Access Compliance Report

Public Rights-of-Way

Intersection ID: 24455	Main Street: S_TRYON_ST	Cross Street: STEELE_CREEK_RD	Location: NW
ADA ID: BAEC7EE59715	Ramp Type: Perp	Initial Pass/Fail: Fail	Overall Compliance: No
		Severity Score: 12.5

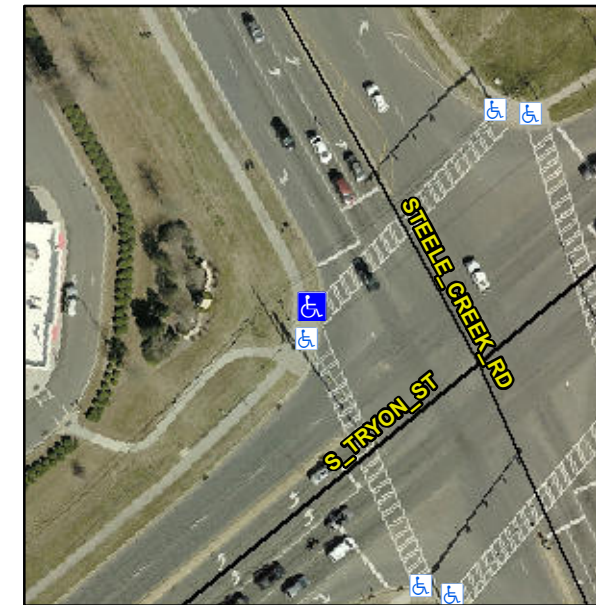
Not Found, R304.2.2

Compliance	Description	Data	Compliance	Description	Data
N/A	Ramp Length (in)	96.0	No	Ramp Slope (%)	9.1
Yes	Ramp Width (in)	48.0	Yes	Ramp XSlope (%)	1.9
N/A	Flare Type LT	N/A	N/A	Flare Type RT	N/A
N/A	Flare Slope LT (%)	N/A	N/A	Flare Slope RT (%)	N/A
N/A	Flare Traversable LT?	N/A	N/A	Flare Traversable RT?	N/A
N/A	Landing Length (in)	N/A	N/A	DWS Provided?	N/A
N/A	Landing Width (in)	N/A	N/A	DWS Contrast?	N/A
N/A	Landing Slope (%)	N/A	N/A	DWS Length (in)	N/A
N/A	Landing X Slope (%)	N/A	N/A	DWS Full Width?	N/A
N/A	Landing Curb? (Y/N)	N/A	N/A	DWS Offset (in)	N/A
N/A	Shared Landing?	N/A			
N/A	Gutter Ponding?	N/A	N/A	Gutter Slope (%)	N/A
N/A	Gutter Lip Ht (in)	N/A	N/A	Gutter X Slope (%)	N/A
N/A	Painted X Walk1?	Yes	N/A	Painted X Walk2?	N/A
	X Walk 1 Direction	To NE		X Walk 2 Direction	N/A
N/A	X Walk 1 Width (in)	120.0	N/A	X Walk 2 Width (in)	N/A
	X Walk 1 Slope (%)	2.6		X Walk 2 Slope (%)	N/A
	X Walk 1 X Slope (%)	0.6		X Walk 2 X Slope (%)	N/A

Remove & Replace Entire Ramp.
